Fremont K8 School

1st

CITY OF LAS VEGAS		DATE:
INTER-OFFICE MEMORANDUM		May 2, 2019
TO: Land Development Services Department of Building & Safety		FROM: Albert Sung, P.E. Flood Control Project Engineer Department of Public Works
SUBJECT:	Drainage Study for: Fremont K-8 School	
Cross Streets:	SWQ of Maryland Pkwy. & St. Louis Avenue	COPIES TO: Lochsa Engineering
File Number:	F:\Depot\DSMemos\DS5124A.doc	Clark County School District
Parcel Number:	162-03-801-005	Bart Anderson, P.E., DevCo
Zoning Action:	SDR-76201 & VAR-76200	
FEMA Flood Zone	YES	NO X
Proposed Storm Drain	YES	NO X

SHEET NO: **DR2**

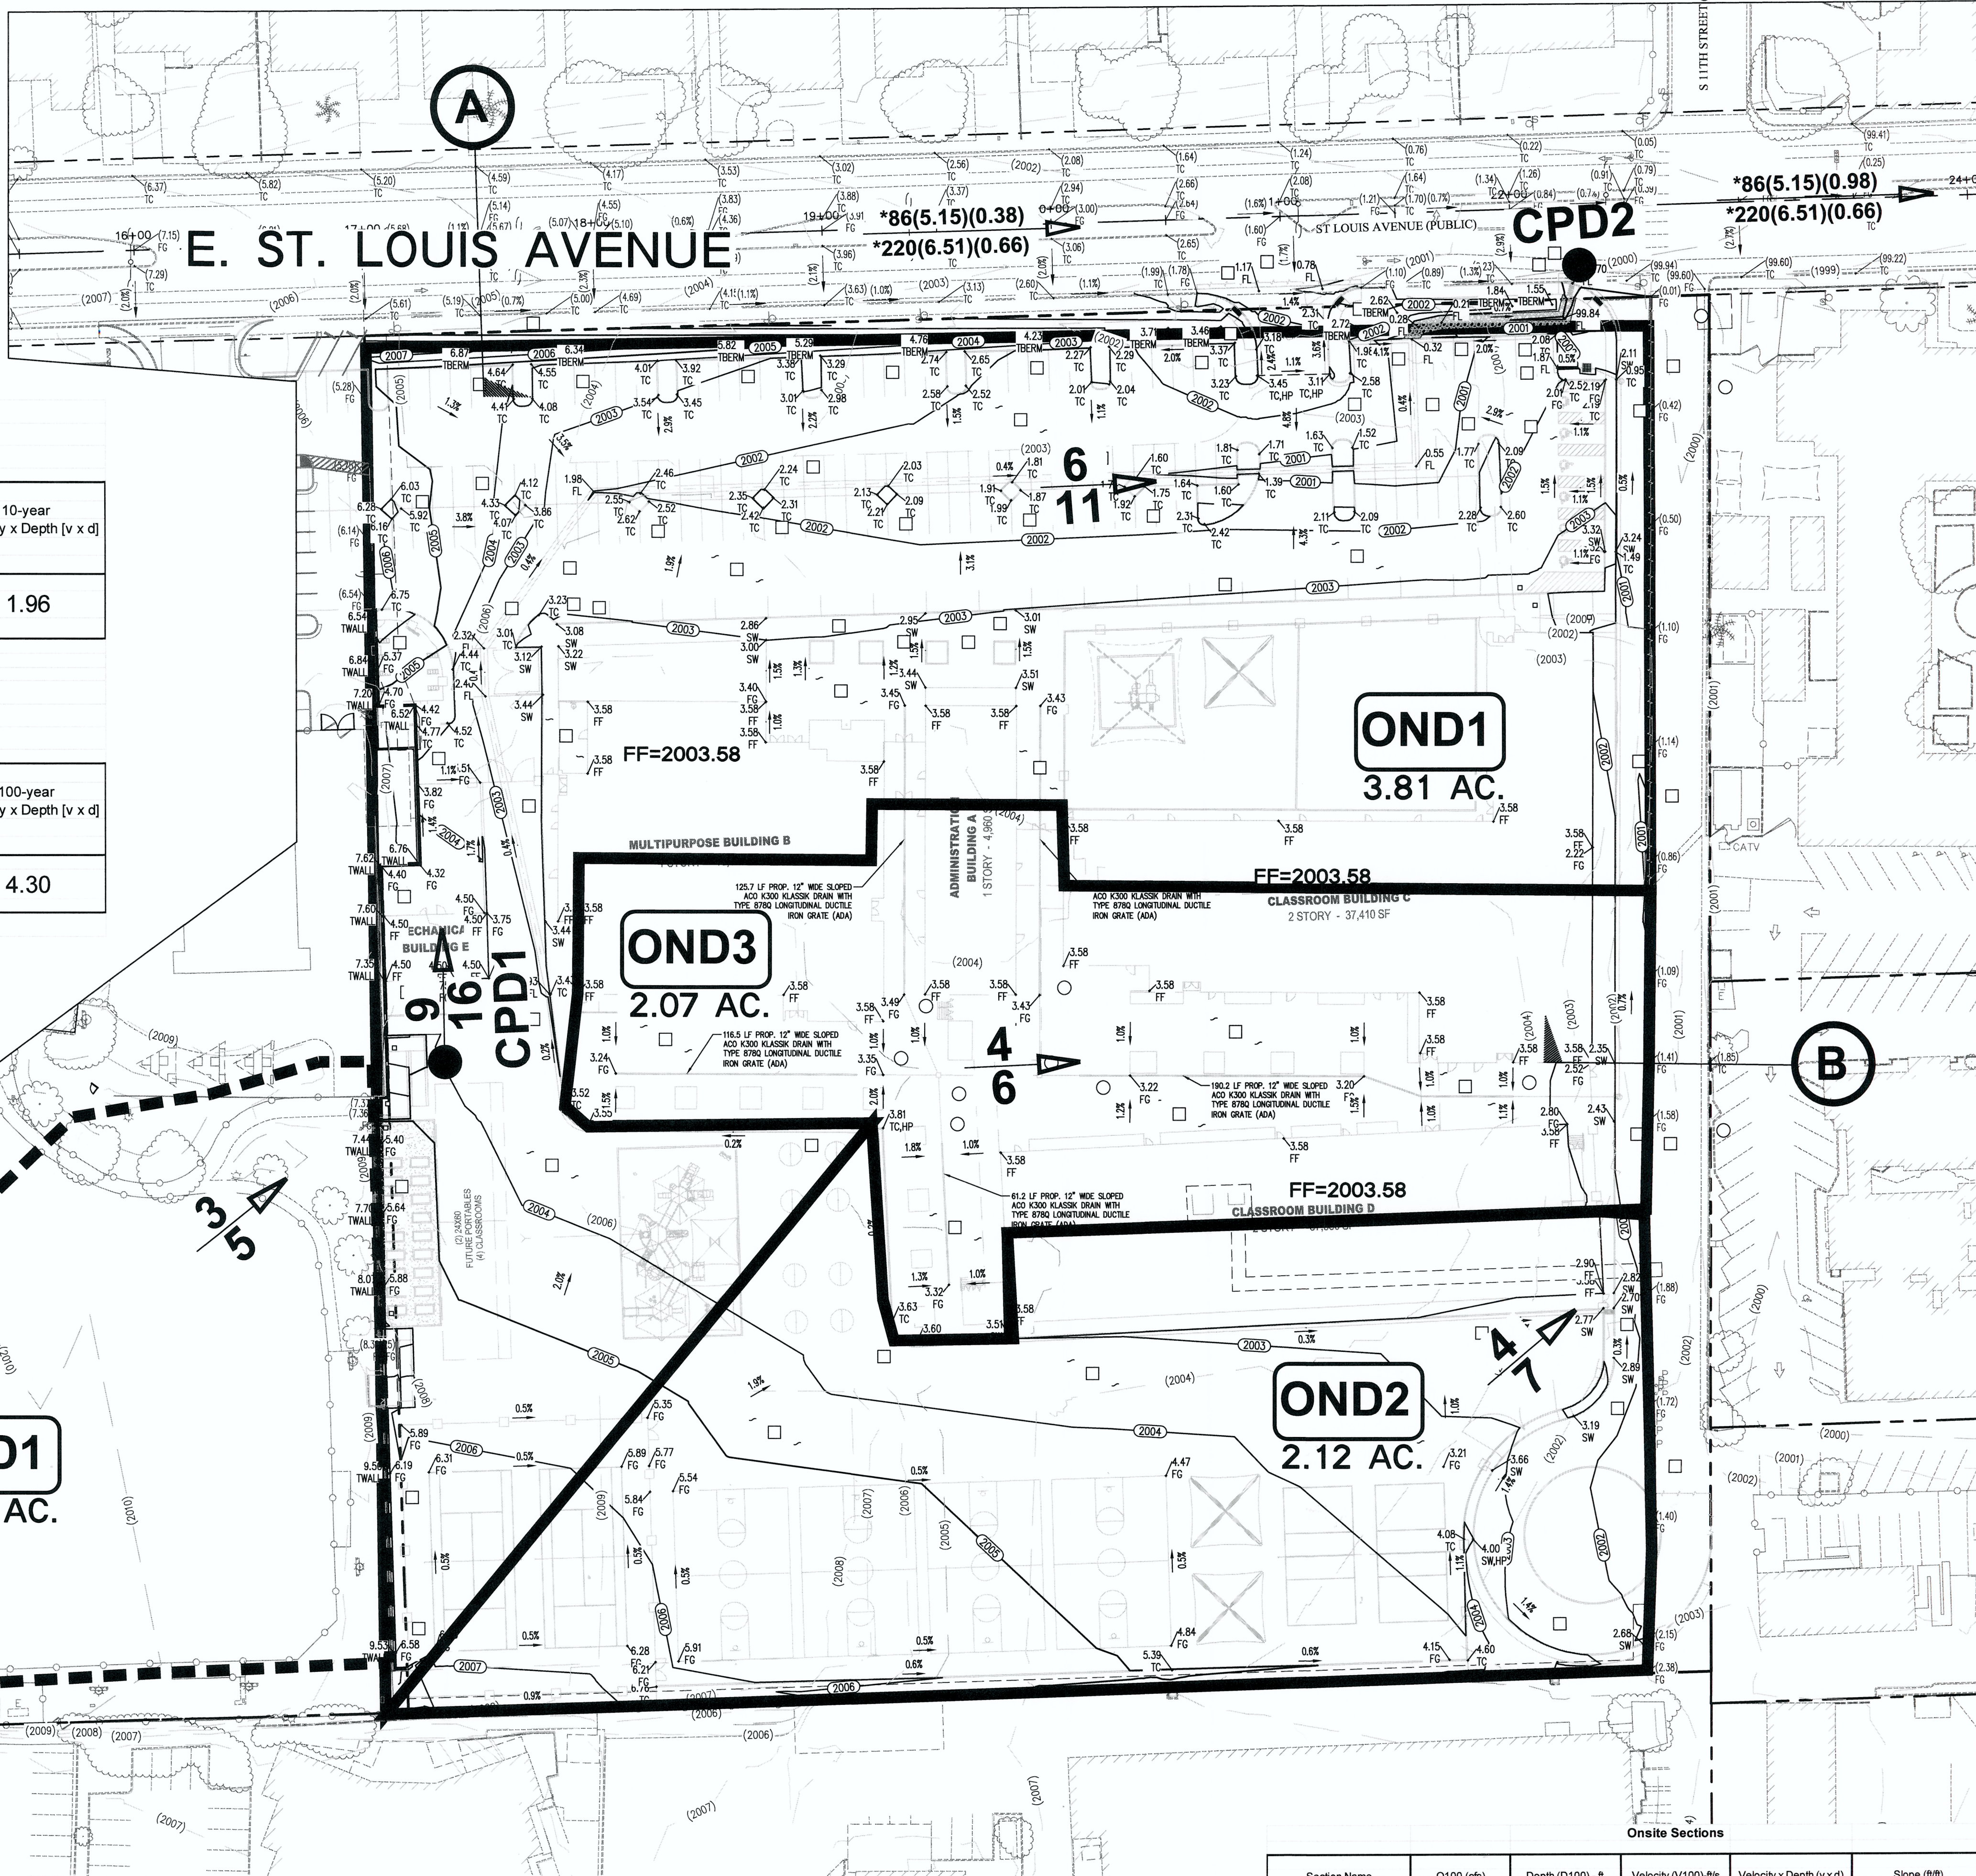
5. *Sheet DR2 (Interim / Developed Basin Map)*: It also appears that the location of concentration point CPD1 is not correct. Review and revise accordingly.

6. Per the *Baker Park Improvement Plans*, it appears that the Park is basically drain through the subject school site which does not agree with the depiction of only *Basin OFD1* is impacting the school site as shown in the subject DR1 and DR2 Basin Maps.

The engineer should reference the drainage basin maps of the *Baker Park* project and include additional offsite basins other than *OFD1* into DR1 and DR2 in the next submittal.

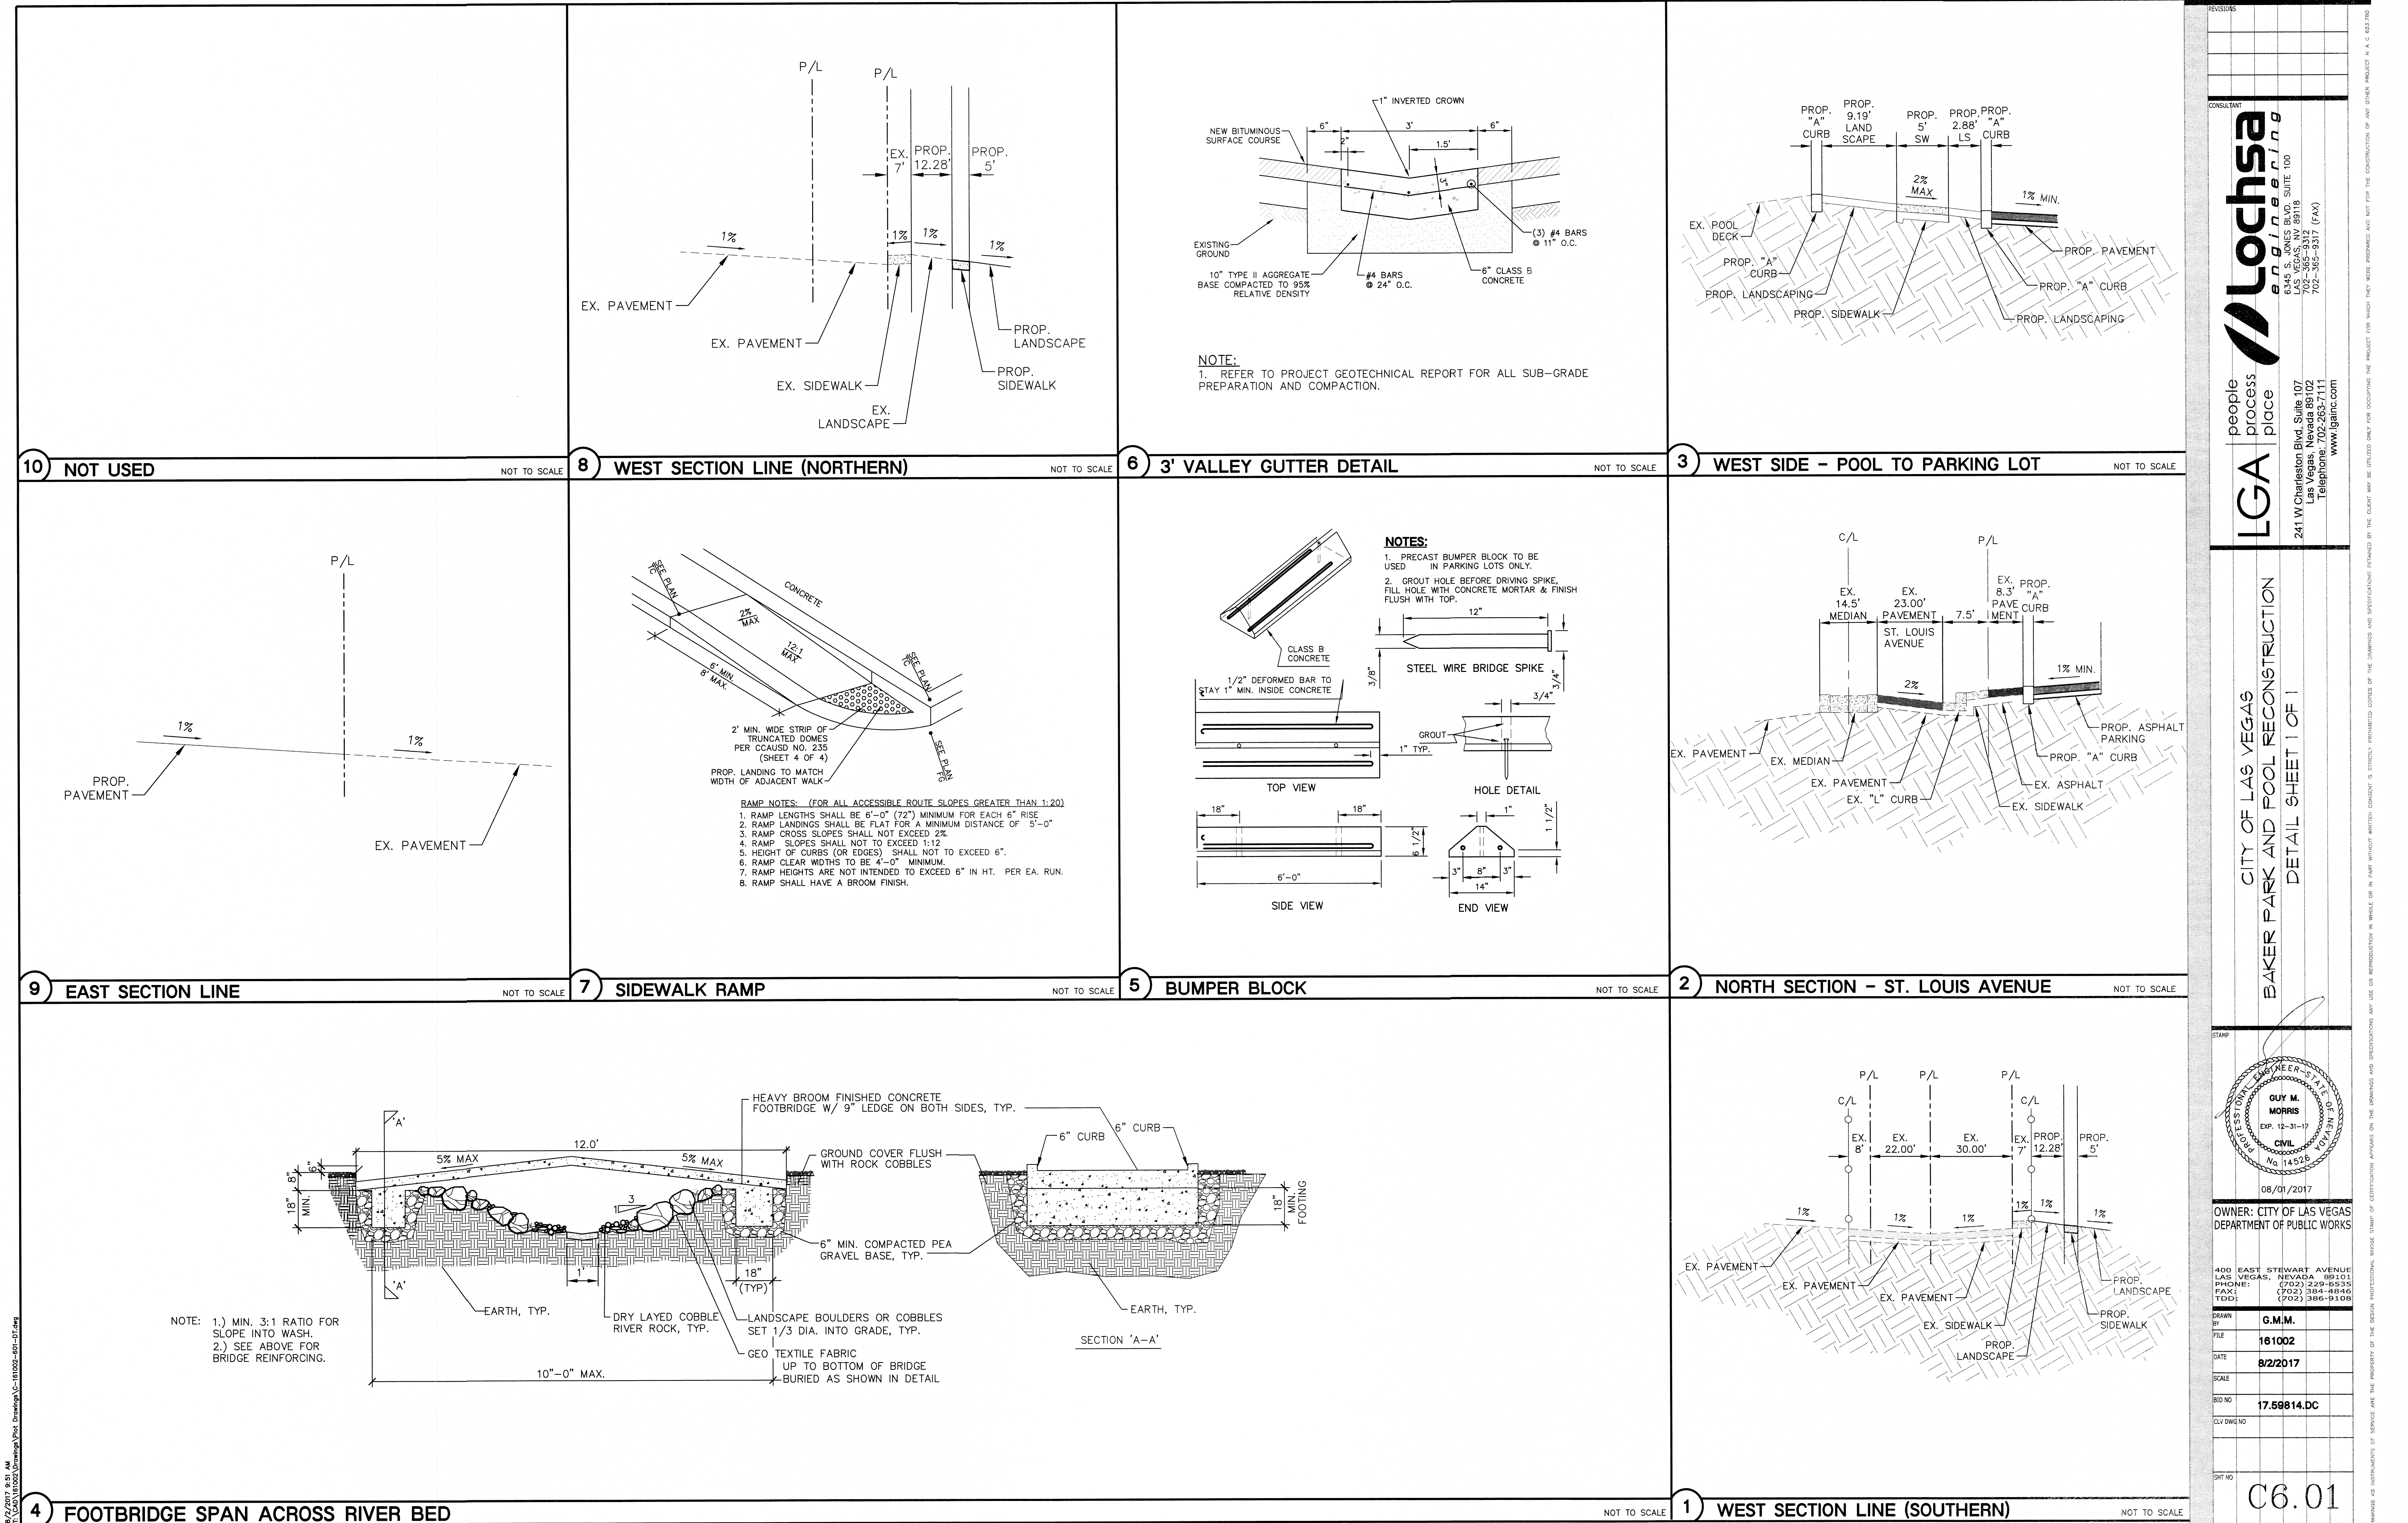
4. *Sheet DR1 (Existing Condition Basin Map)*: It appears that concentration point CPX2 is wrongly located at the east end of the parking lot. Should it be located exactly at the northeast corner of the school site? Review and revise accordingly.
